DRB RECOMMENDATION

2121 5th Ave Seattle, WA

SDCI PROJECT NO.:
3022614

MEETING DATE:
October 17, 2017

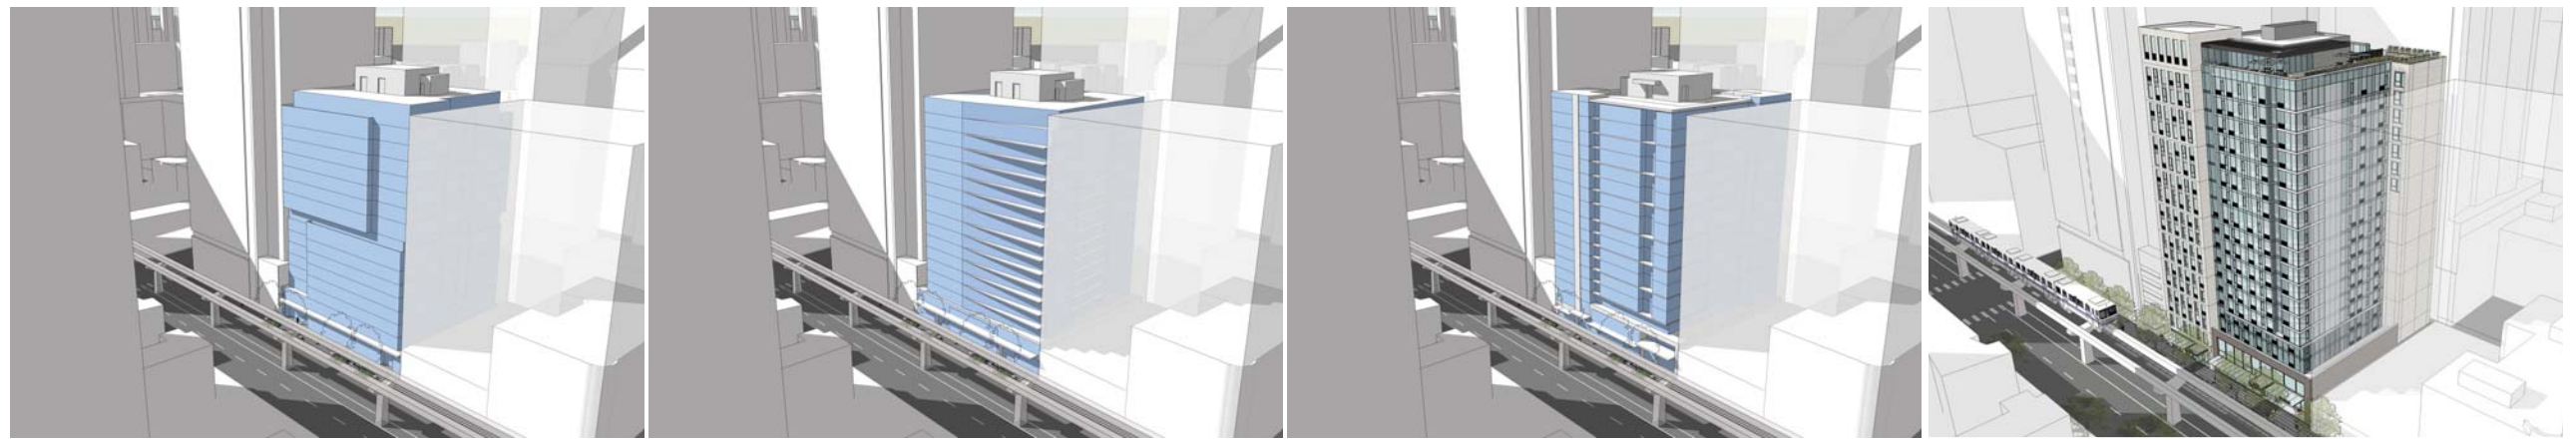
BOARD COMMENTS		DESIGN TEAM RESPONSE	REFERENCE
1a	1. The streetscape: a. See b-3, c-1, c-2, and d-4 priority guidelines.	Noted.	
1b	Reconsider the location and articulation of the restaurant entrance	The design intent is for the restaurant and hotel to share an entrance. The entrance is located between the restaurant and the hotel lobby area. The street facade at the restaurant use is transparent and is proposed as a nanawall-like system whereby the storefront opens up to allow for a connection to the public at the sidewalk and allows for the option of outdoor seating.	Level 1 Plan, pg. 26 Views, pg. 44
1c	Consider Insetting The Walls Of The Proposed Restaurant To Provide For Sidewalk Seating; The Proposed Valet Station And Complicated Structural Elements Would Seem To Interfere With Any Indoor/Outdoor Restaurant Flexibility.	The transparent wall at the restaurant use area has been inset 6 feet from the property line allowing for the potential of outdoor seating and therefore making a stronger connection to the pedestrian experience.	Level 1 Plan, pg. 26 Views, pg. 44

1d	Explore a folding wall at the sidewalk edge for restaurant	There are two folding wall sections along the street level facade; a nanawall-like system is proposed at the small retail area on the northeast side and at the restaurant.	Views, pg. 44
1e	Provide canopies of staggering heights across front of the building.	Canopies are proposed in a continuous manner along the project street frontage. The heights of the canopies are shown at 10 ft. High at the retail and lobby areas, and a height of 15 ft. Is shown over the two building entrances and restaurant. This draws attention to the entrances and creates a more interesting space in the public right of way with canopy height variation.	Elevations, pg. 36 Views, pg. 43
1f	Provide for the next meeting vignettes and sections that illustrate more clearly the functioning of the interior stair located in between entries at the middle of the ground-level 5th avenue facade.	The stair connecting the ground level and second level uses at the street-front facade has been removed from the design. The lobby space at the street-front facade is still a double-height space providing a spatial and visual connection between the two levels.	Level 1 Plan, pg. 26 Level 2 Plan, pg. 27

1g	Provide east/west sections to help explain ground and lower level relations to sidewalk, streetscape, and the monorail structure	A site section in the east/west direction has been provided on sheet a4.00 Demonstrating the physical relationship of the lower level floors of the project to the adjacent monorail structure. The levels most significantly effected by the monorail structure are levels 3 and 4 and these levels have been pulled back as a response to that adjacency. Exterior lighting at the window wall facade on these levels facing the monorail has been incorporated to provide some level of privacy to the hotel rooms on that level. Lighting will illuminate that facade on those levels, reflecting off the glass surface and thereby reducing transparency from the exterior to the interior. The details of the streetscape and relationship of the street-level facade to the sidewalk area are shown in the section as well, however the enlarged elevation best describes the interaction of the street-level uses with the public right-of-way.	Site Section, pg. 49 Views, pgs. 42-45

2a	Massing Details: See b-3, b-4, c-2 guidelines. The board preferred the third massing option which set the basically unmodulated south third of the front facade slightly proud of the rest of the building's front which was modulated with inset ribbons of balconies from above the base to the top. The overall effect was to impart a strong vertical cast to the 115 foot wide by 170 foot tall box.	The project design presented in this mup application is consistent with the third massing option presented in the edg meeting. There is a strong and solid corner tower-like element on the south side of the street-facing facade with a separate "box" floating over the lower podium levels. The fenestration pattern of the "box" is clearly different from the tower element and this mass appears lighter with use of a high level of glazing. This design massing is radially symmetrical in plan such that the massing is shown in a similar fashion on the alley-facing facade. The strong vertical language of the facade remains with this massing approach and the ribbon created by the recesses of the "box".	Elevations, pgs. 35-38 Views, pgs. 42-45

2b	It is unclear how the 5th avenue facade is intended to interact with the monorail or monorail structure.	In response to the adjacency of the monorail along the 5th avenue facade, the levels that align with the monorail elevation have been recessed back approximately 3 feet from the rest of the facade above. This creates a strong shadow line at the elevation of the monorail visually minimizing those two levels from public view. Another design feature employed at the third and fourth levels is the application of lighting to cast light at the facade which can provide some level of visual privacy from the passing monorail. This lighting is intended to be minimal, visually interesting, compliment the architecture, and be non-invasive the to the hotel guests.	Site Section, pg. 49 Views, pgs. 45 & 55
2c	Provide east/west sections that show the monorail as a determinative factor for the articulation of the lower floors and setbacks.	A site section in the east/west direction has been provided on sheet a4.00 Demonstrating the physical relationship of the lower level floors of the project to the adjacent monorail structure. The levels most significantly effected by the monorail structure are levels 3 and 4 and these levels have been pulled back as a response to that adjacency.	Site Section, pg. 49
